PROPOSAL REQUEST

PROJECT:	LXT Hangar 2 Eastside Development	PROPOSAL NO:	10
OWNER:	City of Lee's Summit	DATE OF ISSUANCE:	04/01/25
TO:	Fogel-Anderson Construction 1212 E. 8th Street Kansas City, MO. 64106	ARCHITECT:	Wellner Architects, Inc. 1627 Main Street, #100 Kansas City, MO 64108
COPY:	File		
CONTRACT FOR:	General Construction	ARCHITECT'S PROJECT:	2219
CONTRACT DATE:

A102

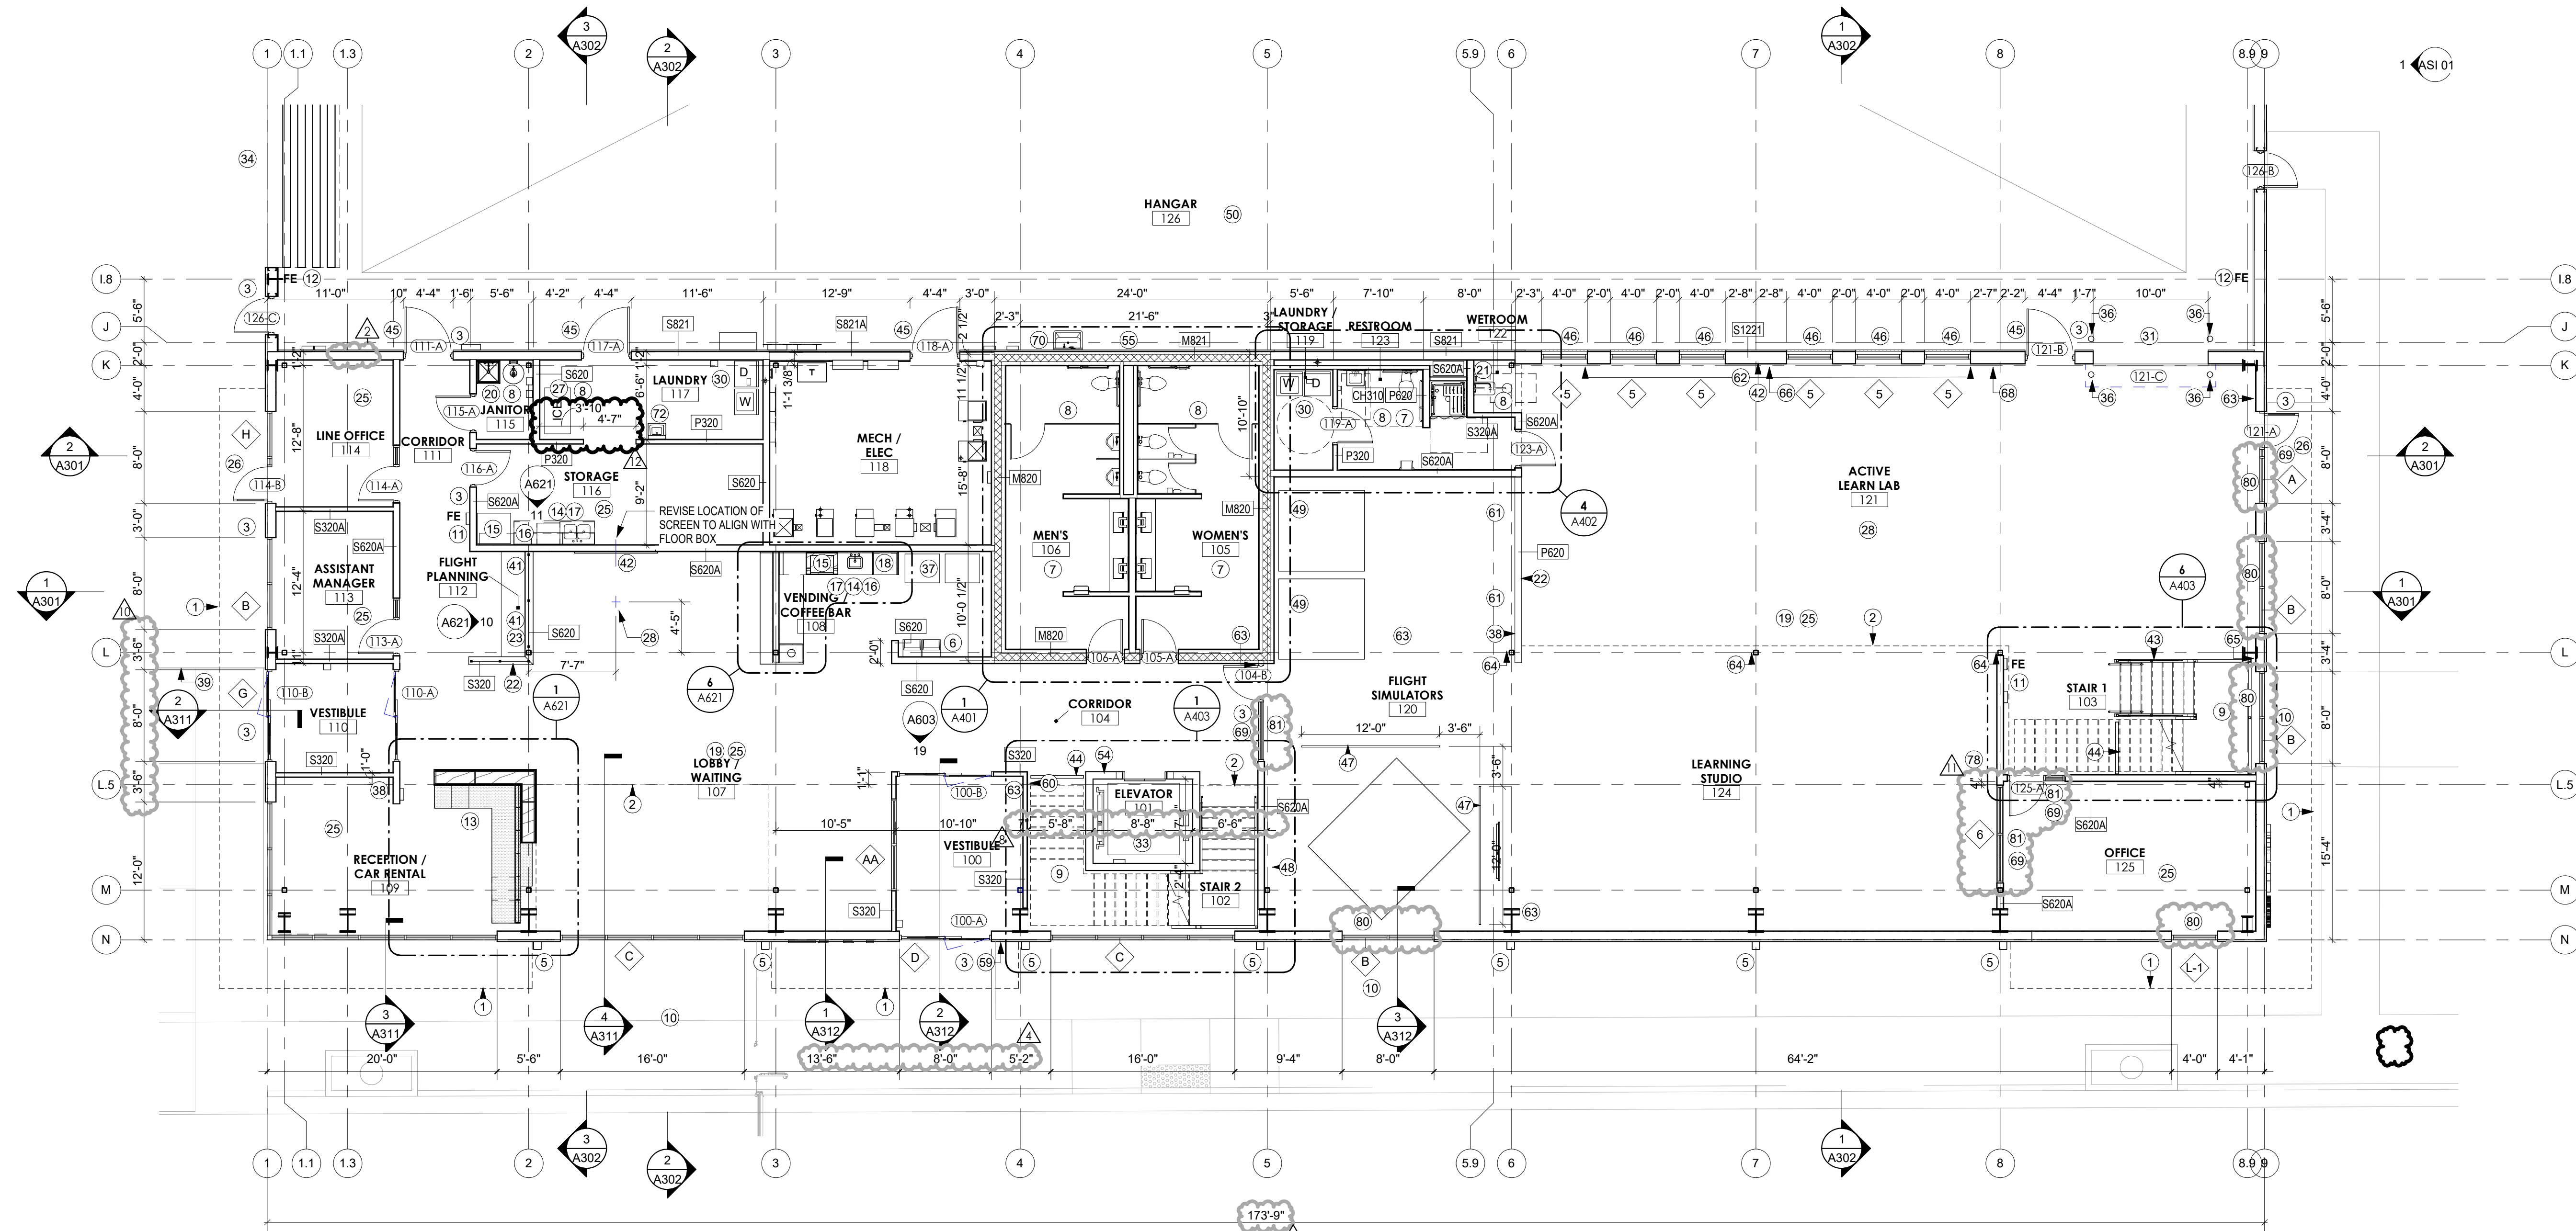
Item 1. SHEET A102 FLOOR PLANS:

LAUNDRY rm 117 **Revise** opening size into STORAGE rm 116

E201

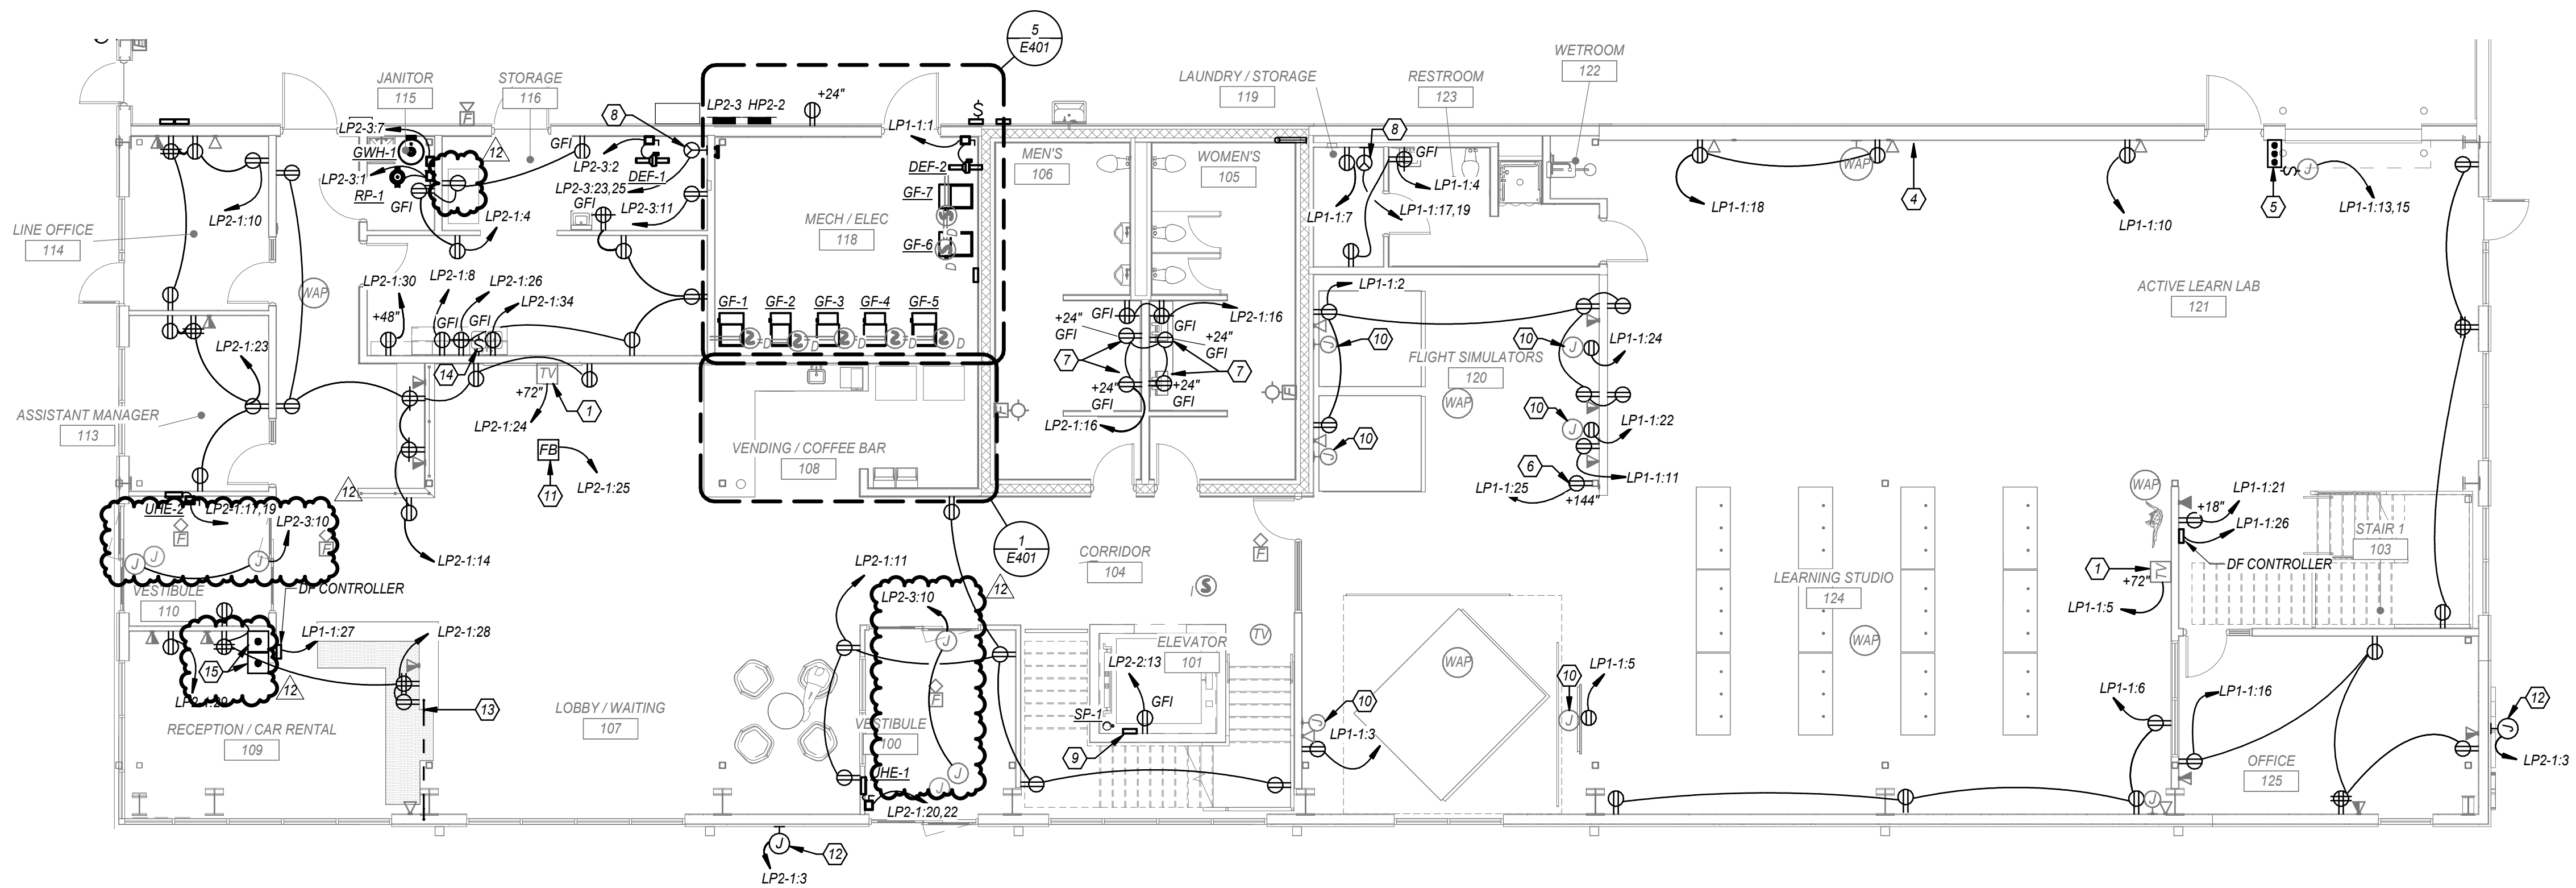
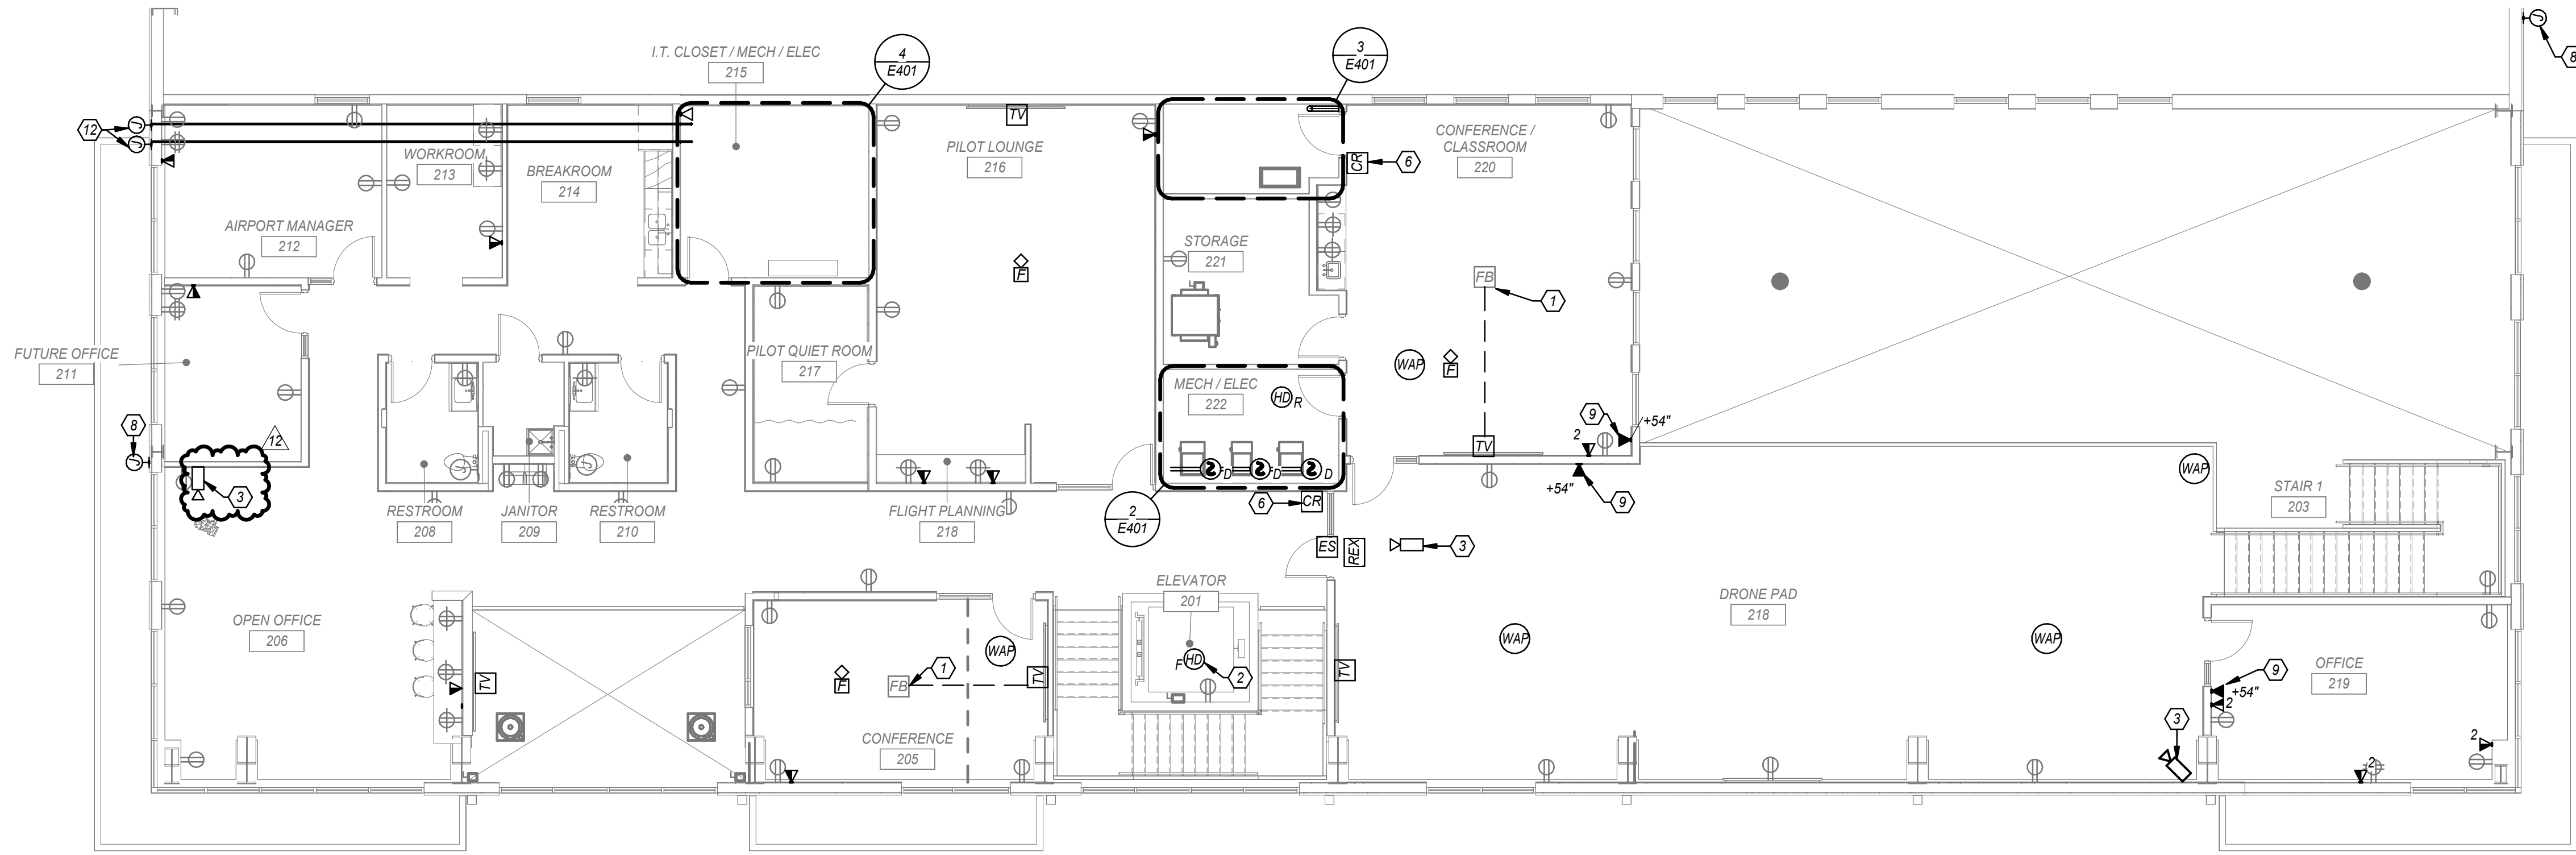
Item 2. SHEET E201 POWER FLOOR PLANS:

VESTIBULE rm 100 **Add** power for sliding doors 100-A and 100-B

VESTIBULE rm 110 **Add** power for sliding doors 110-A and 110-B

RECEPTION / CAR RENTAL rm 109 **Add** conduit as desk for access control of sliding doors at Vestibules 100 and 110.

ELECTRICAL KEYNOTES **Revise** note 4. zxAdd note 15.

- 15 PROVIDE 1" CONDUIT AND JUNCTION BOX FOR (2) DESK MOUNTED PUSH BUTTONS. CONDUIT SHALL BE ROUTED BACK TO ACCESS CONTROLS FOR LOW VOLTAGE WIRING. COORDINATE ALL REQUIREMENTS WITH ACCESS CONTROLS PROVIDER AND OWNER.

E301

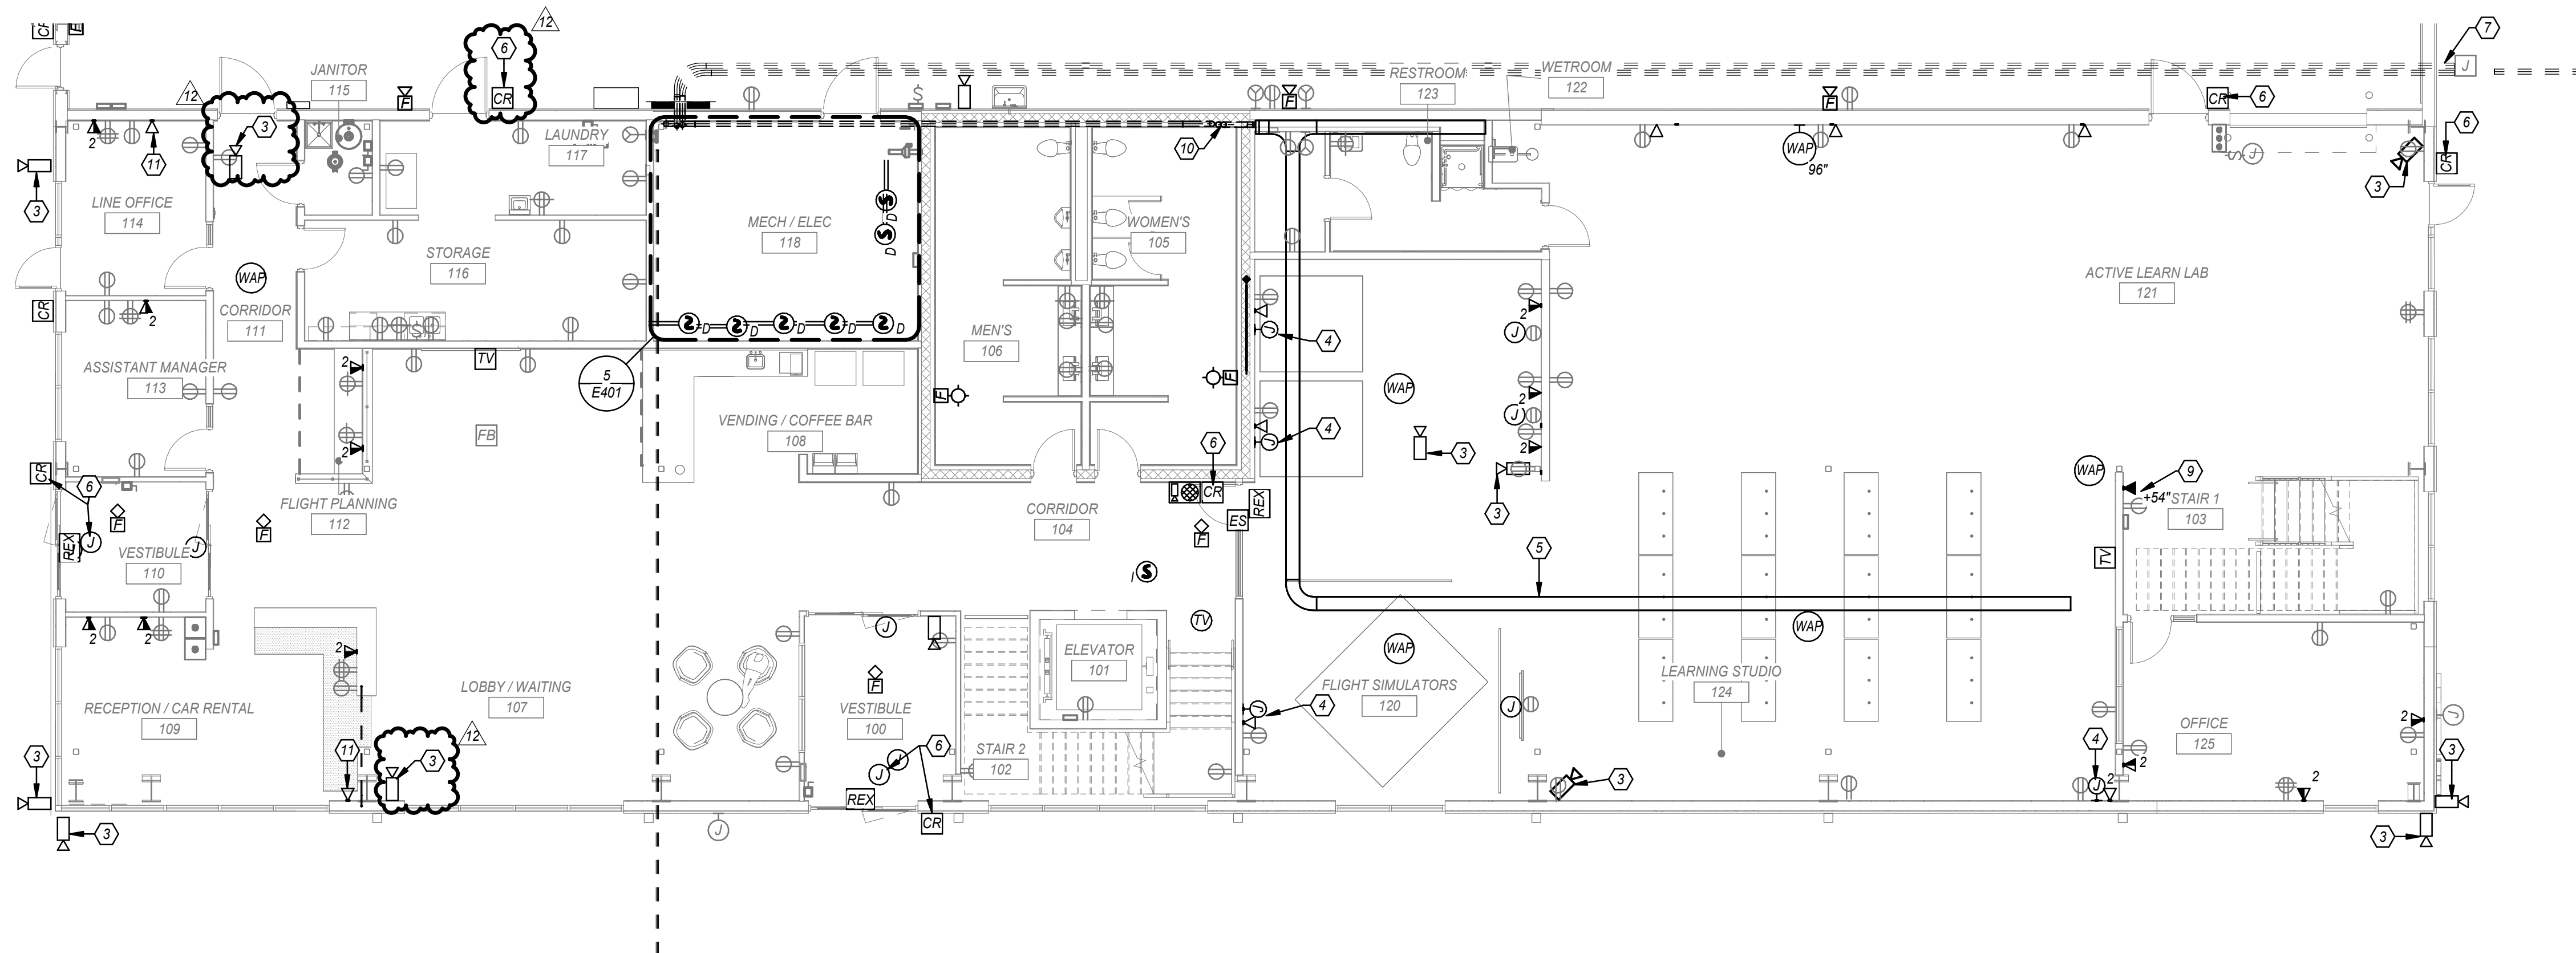
Item 4. SHEET E301 SYSTEM FLOOR PLANS:

LOBBY / WAITING rm 107 **Add** box and conduit for camera.

CORRIDOR rm 111 **Add** box and conduit for camera.

- PROVIDE JUNCTION BOX AND 3/4" CONDUIT ROUGH IN FOR CAMERA. ROUTE CONDUIT BACK TO IT ROOM. COORDINATE EXACT LOCATION AND REQUIREMENTS WITH OWNER AND SECURITY PROVIDER. IN AREAS WITH NO ABOVE CEILING ROUTE CONDUIT HIGH AND TIGHT TO STRUCTURE ABOVE.
